E5515B-05

S E R V I C E N O T E

E5515B Wireless Communications Test Set (8960 Series)

Lockup During Power-up Requires Replacement of Protocol Processor

Figure 1

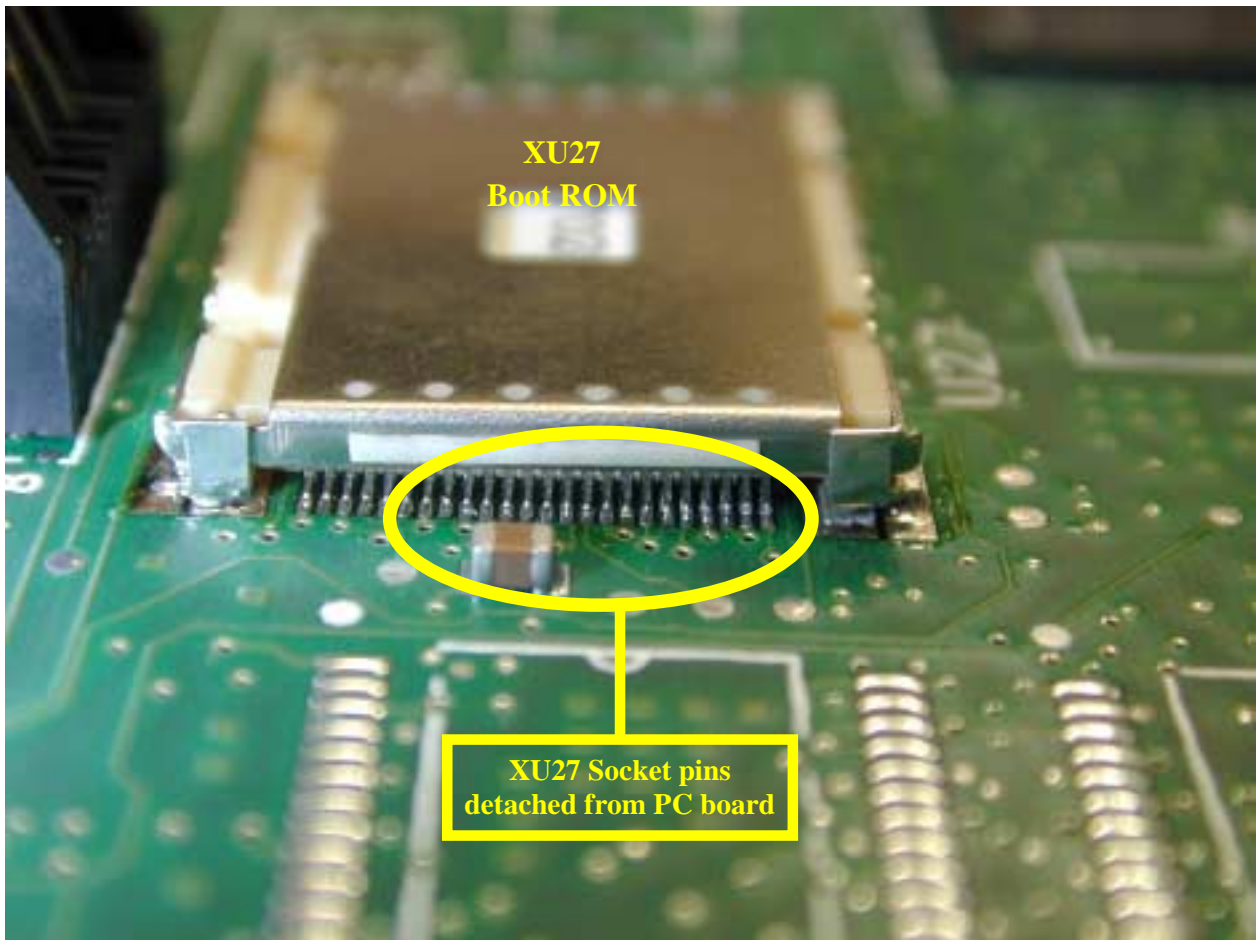
The Protocol Processor (Agilent P/N E5515-60359) may cause the test set to lockup during the protocol boot initialization portion of the power-up process or during normal operation. The test set may also restart, depending on the TA (Test Application) version being used. A manufacturing defect caused the socket for the Boot ROM (XU27) to detach from the PC board. An example of a defective board is shown in Figure 1.

Replace the Protocol Processor using Repair Kit E5515-61850 and verify that the test set powers-up correctly.

Figure 2

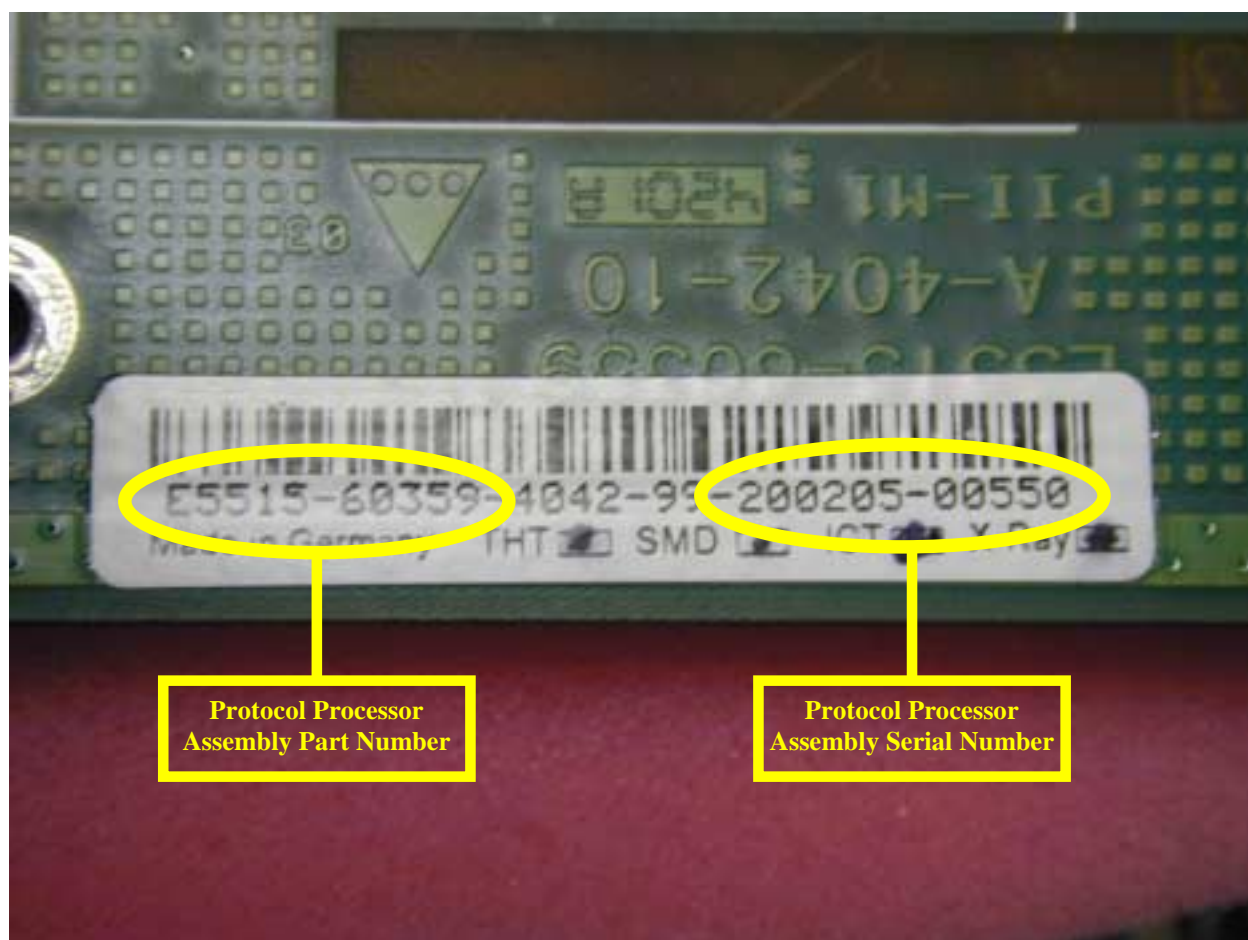
Label inspection: Figure 2 shows a label on board part number E5515-60359 with board serial number 200205-00550, which corresponds to year 2002, 5th week, serial number 00550.
